**Chemung County Stormwater
Construction Inspection
Erosion and Sediment Control**

| Project Name Hilliard Expansion | Date 8-26-2019 |
| Location Magee Street Elmira (City), NY | Permit # NYR11F218 |

PROJECT: Hilliard Expansion
City of Elmira
Municipal Inspection
August 26, 2019

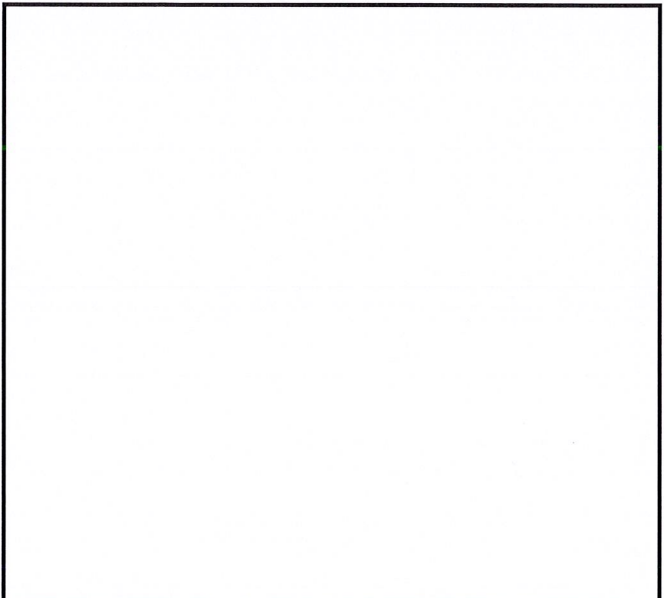
Sediment on Magee street needs to be swept up and disposed of properly

Sediment on W. third street needs to be swept up and disposed of properly.

Concrete washout in working order.
